DAEWOO MODEL 531 MONITOR REPAIR KIT 42107

PARTS SHOWN CLOSE TO SCALE

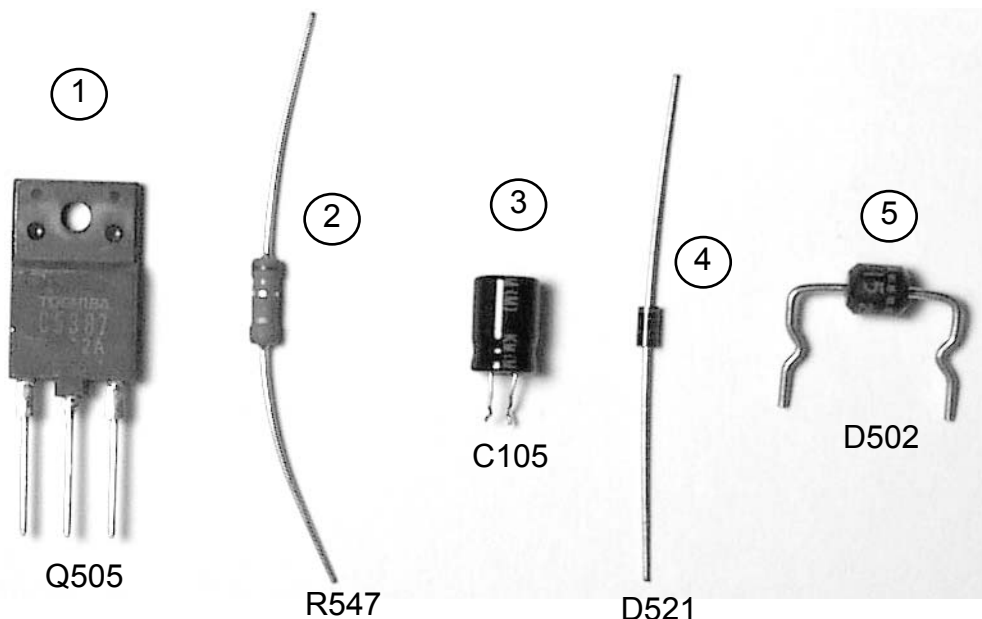
1. Use this kit for DAEWOO Models: 531, 531B, 531X, 531XN.
2. Symptoms: No power, no video, weak or dim video.
 1. Replace **Q505** with **2SC5387**.
 2. Replace **R547** with **0.68 Ohm 1Watt** resistor (BLUE, GRAY, SILVER, GOLD).
 3. Replace **C105** with **330uF @ 25V** electrolytic capacitor.
 4. Install **TVR1G** diode at location **D521**
 5. Install **ERD07-15** diode at location **D502**.
 6. Remove **C518** capacitor.
